Subject: Review of Site Investigation Report and Request for Additional Information
S.C. Johnson & Son, Inc. - Waxdale Facility
8311 16th Street, Sturtevant, WI 53177
BRRTS Activity #: 02-52-552979; FID #: 252006370

The Wisconsin Department of Natural Resources (DNR) has reviewed the submittal, *Site Investigation Report, S.C. Johnson & Son, Inc. - Waxdale Facility, BRRTS #: 02-52-552979*, (Report), dated June 30, 2021, and prepared by AECOM Technical Services, Inc. (AECOM). The Report was prepared in response to a request from the DNR to submit a comprehensive site investigation report for the Waxdale Facility.

FIGURE 1-2

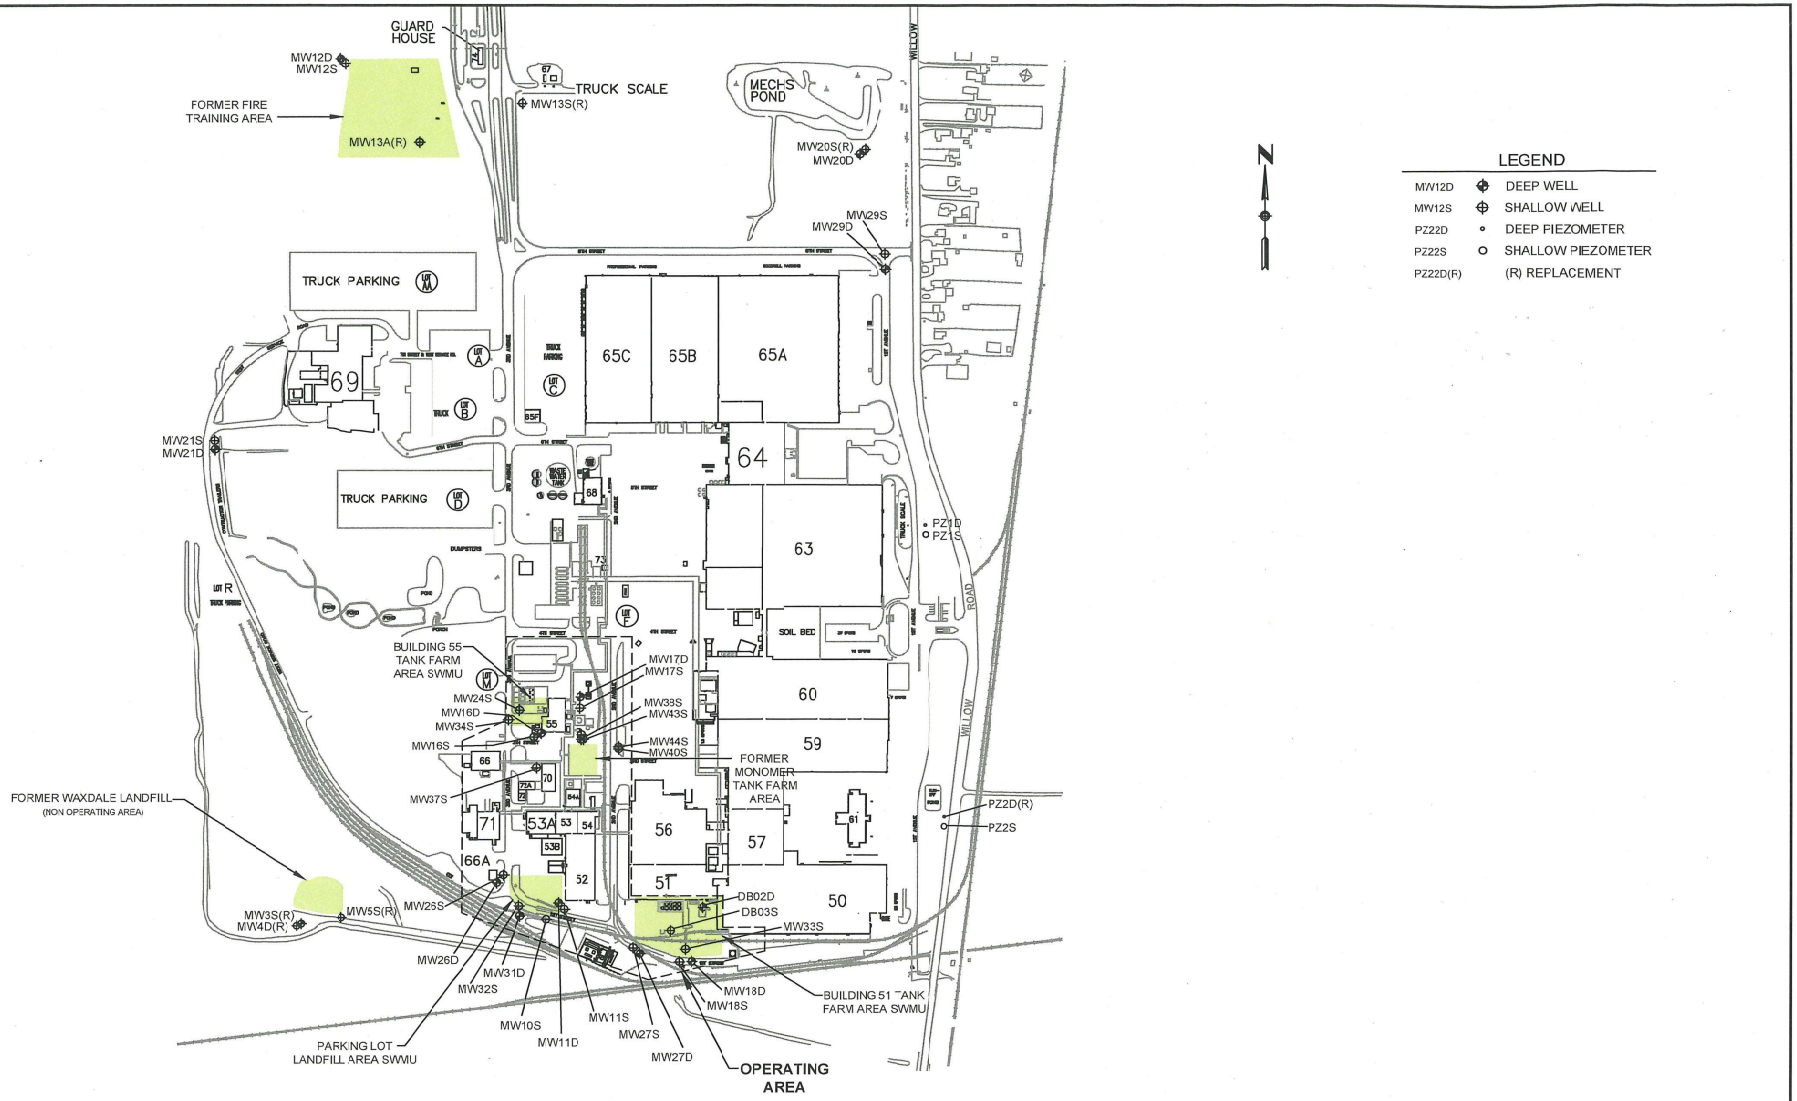
- The Report needs to include evaluation and/or discussions of impacts to wetlands and surface water. Also show clearly on the maps the areas of wetlands and surface water.
